Bellevue Planning Commission

Downtown Livability – Review of Draft Downtown Land Use Code Amendment (LUCA)

The following matrix summarizes initial direction from the Planning Commission regarding changes to the March 8, 2017 Public Hearing Draft of the Downtown Land Use Code. The Commission’s initial direction has been incorporated into a Consolidated Draft Land Use Code Package for Commission consideration. Final Commission direction on the code package will provide the basis for its recommendation to the City Council. The Consolidated Draft Land Use Code Package is Attachment A.

~~2-16-17 Draft~~ 5.5.17 Consolidated Draft

Figure 20.25A.060.A.2

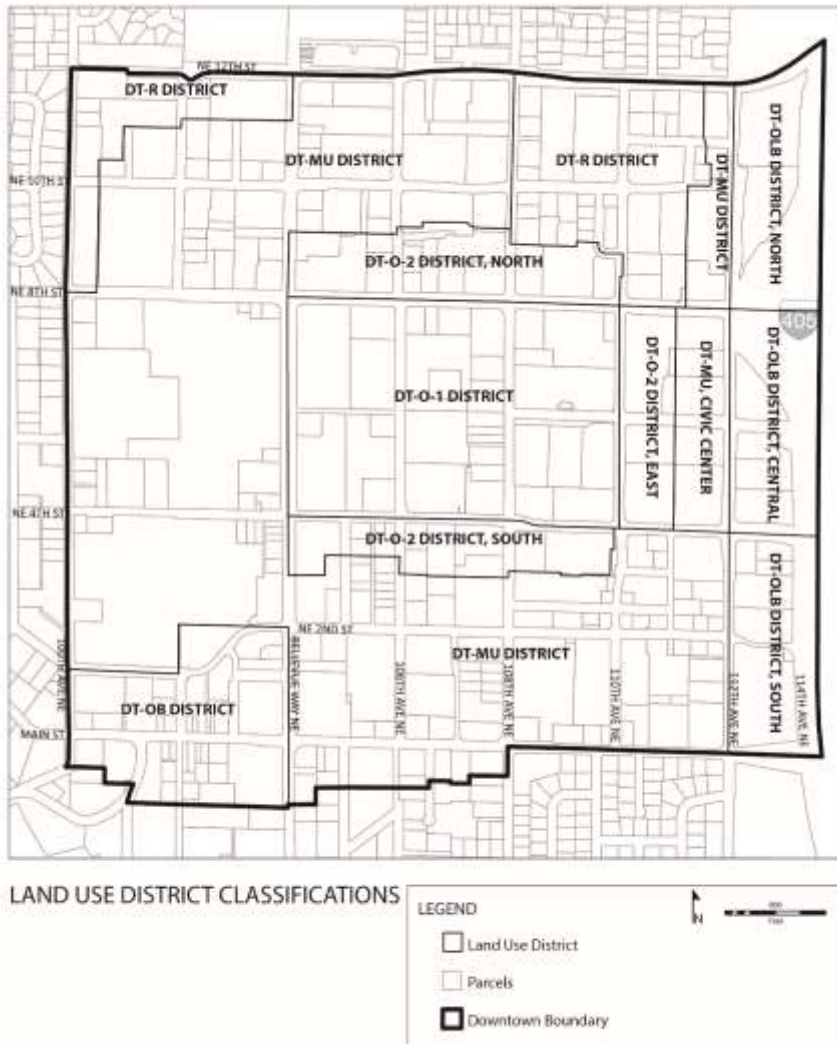
Commented [HC32]: MOVED from 20.25A.020.A.2 and UPDATED to respond to CAC and Planning Commission direction.

ADDED in 15' or 15% to maximum height for transparency. Increased max. FAR in some districts.

Figure 20.25A.060.A.3

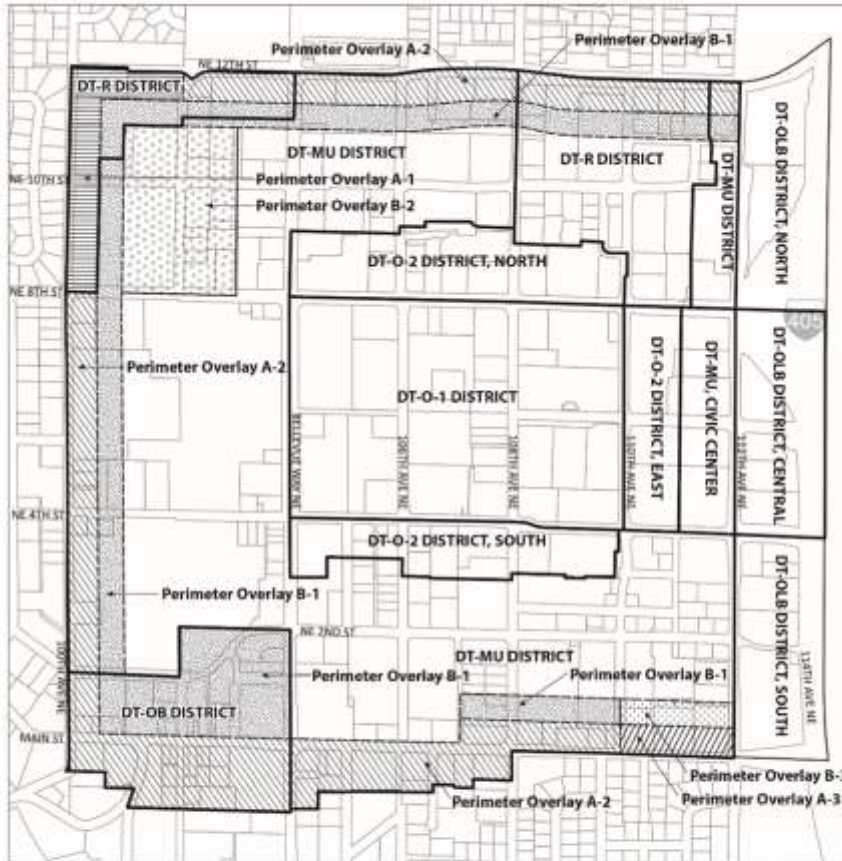
INSERT MAP Initial PC Direction 4.19.17

Commented [BT(33)]: Initial PC direction on 4.19.17 was to substitute Perimeter Overlay A-2 in for Perimeter Overlay A-1 on 112th Ave. NE from 102nd Ave. NE to 112th Ave. NE

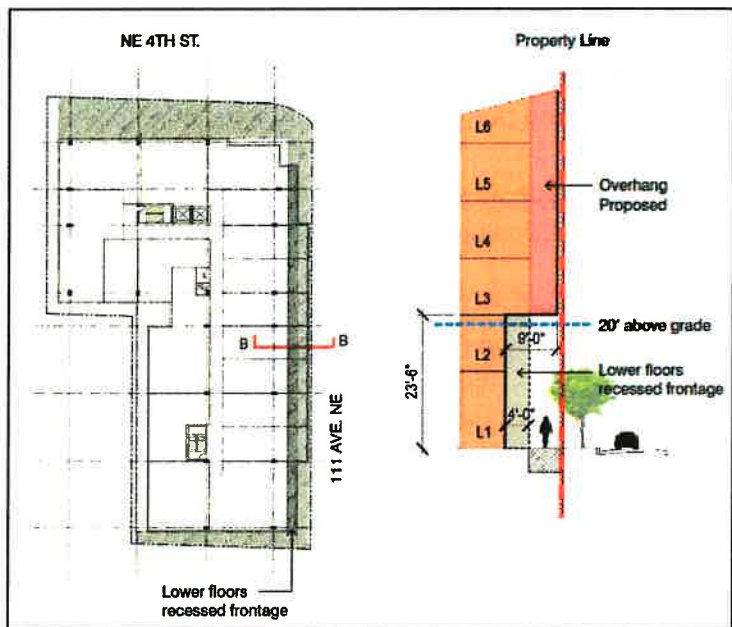
The adjacent diagram shows the floorplan and elevation of the proposed residential project on the 4th & 111th site. Due to the tight site, in order to achieve a full floorplate we need to build back out to our property line at an appropriate vertical elevation. The sidewalk and enhanced streetscape requirements push the ground floor back nine feet from the property line. Maintaining this up to 20' in elevation is not ideal, but it's workable. But if we are required to continue the setback for the entire vertical elevation of the building we would lose too much rentable area (see the grey cross-hatching on the left figure).

Proposed solution: Add a new Subsection .060.2.a.iii. "On Mixed Street and Neighborhood Streets, Building structure, external decks and balconies are permitted to extend over the
